Access Compliance Report

Public Rights-of-Way

(Curb Ramps)

Intersection ID: 43985	Main Street: CANYON_CREEK_LN	Cross Street: N_HOSKINS_RD	Location: SW
ADA ID: 28148424DA27	Ramp Type: Perp	Initial Pass/Fail: Fail	Overall Compliance: No Severity Score: 22.5

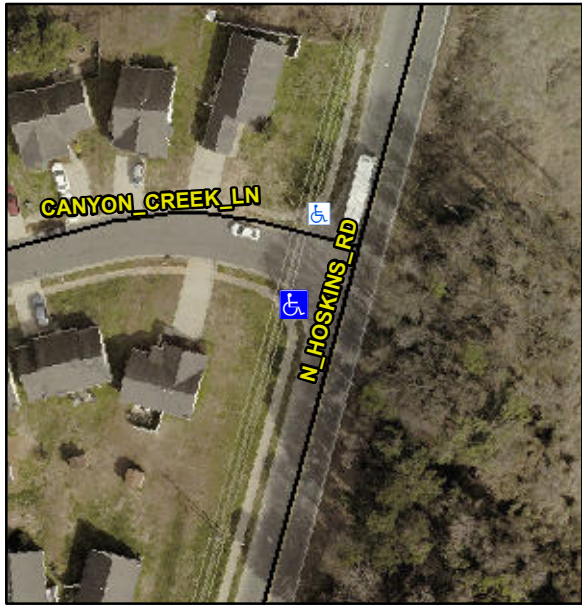
Codes/Mitigation Info/Possible Solution			Field Measurements/Component Compliance					
	Possible Solutions:		Compliance	Description	Data	Compliance	Description	Data
	Remove & Replace Entire Ramp.		N/A	Ramp Length (in)	107.5	No	Ramp Slope (%)	9.7
			No	Ramp Width (in)	37.0	No	Ramp XSlope (%)	3.1
			N/A	Flare Type LT	N/A	N/A	Flare Type RT	N/A
			N/A	Flare Slope LT (%)	N/A	N/A	Flare Slope RT (%)	N/A
			N/A	Flare Traversable LT?	N/A	N/A	Flare Traversable RT?	N/A
			N/A	Landing Length (in)	N/A	N/A	DWS Provided?	N/A
			N/A	Landing Width (in)	N/A	N/A	DWS Contrast?	N/A
			N/A	Landing Slope (%)	N/A	N/A	DWS Length (in)	N/A
			N/A	Landing X Slope (%)	N/A	N/A	DWS Full Width?	N/A
Surveyor Notes:	N/A		N/A	Landing Curb? (Y/N)	N/A	N/A	DWS Offset (in)	N/A
			N/A	Shared Landing?	N/A			
	PROW/ADA:		N/A	Gutter Ponding?	N/A	N/A	Gutter Slope (%)	N/A
	Not Found, R304.5.1, R304.2.2, R304.5.3		N/A	Gutter Lip Ht (in)	N/A	N/A	Gutter X Slope (%)	N/A
